ITEM	10 Nelson Short Street, POTTS HILL
	Construction of a Seniors Living Development comprising of six (6) buildings with a total of 224 dwellings and ancillary uses including a medical centre, café, retail shop, restaurant/lounge, outdoor swimming pool, with communal landscaped areas and on-site basement car-parking.
FILE	DA-845/2017 - Bass Hill Ward
ZONING	B7 Business Park
DATE OF LODGEMENT	12 September 2017
APPLICANT	Mecone
OWNERS	Potts Hill Group Pty Limited
ESTIMATED VALUE	\$70,635,855
AUTHOR	Development Services

SUMMARY REPORT

Development Application No. DA-845/2017 proposes construction of a seniors living development comprising of six (6) buildings with a total of 224 dwellings and ancillary uses including a medical centre, café, retail shop, restaurant/lounge, outdoor swimming pool, with communal landscaped areas and on-site basement car-parking.

Attachment A – ASSESSMENT REPORT

Illustration of where proposed development breaches the building height of 16m prescribed in the BDCP 2015

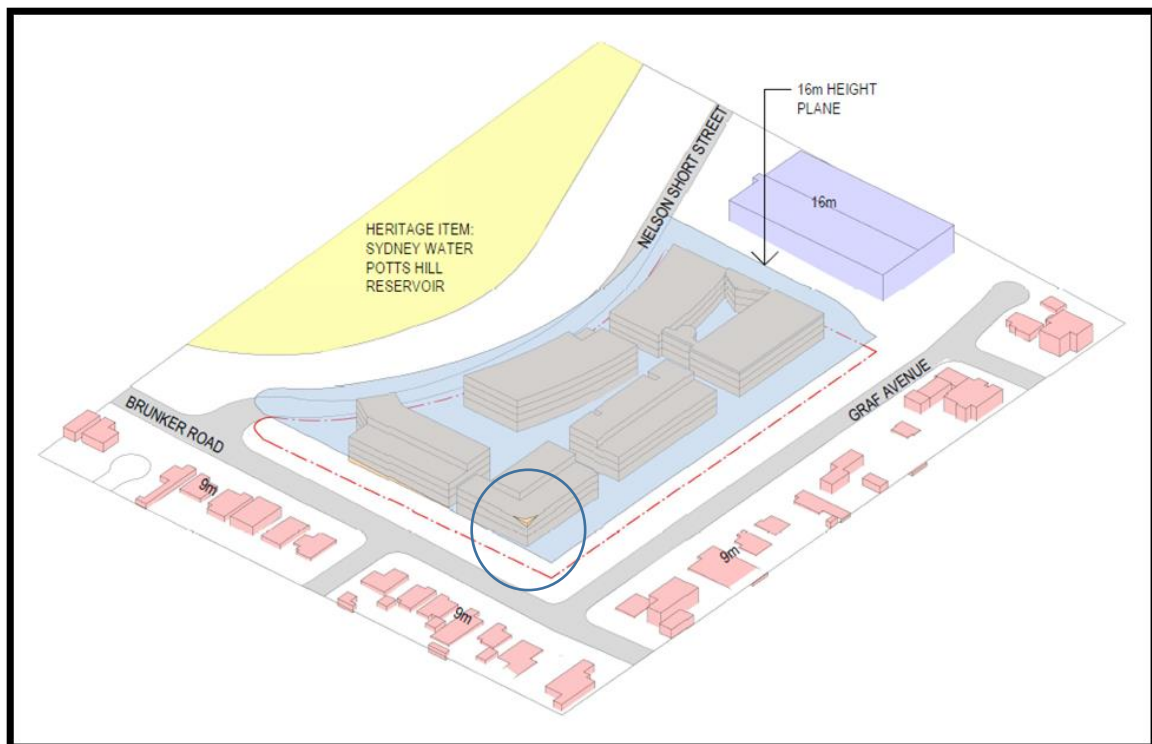
The diagram below demonstrates where the development fails to comply with the 16m maximum building height plane:

As indicated in the diagram above, the vast majority of the development sits below the 16m height limit. A very small portion of proposed Building C breaches the height plane in the south eastern corner of the site. This is due primarily to Building C extending slightly into the part of the site where the site falls rapidly from the predominantly flat (between RL55-56.5m) platform level that covers the majority of the site, down to the street level at the southeast corner (RL47.5m). At the point of worst case, the height of the building measures 18.69m. However, apart from this minor breach in the southeastern corner of Building C, the remainder of the development sits below the maximum building height permitted under the BDCP 2015. The minor breach in height will not result in significantly different levels of impact when compared to a development that complies with the height. It is worth noting that residential dwellings on the southern side of Brunner Rd are setback at least 35m from the proposed location of Building C, and residential dwellings on the eastern side of Graf Avenue are setback at least 43m from the same location.

Based on the above, it is considered that the building height of the proposed development remains appropriate, despite exceeding the threshold at which the consent authority cannot refuse under Clauses 48(a) and 50(a) of the Seniors Living SEPP.
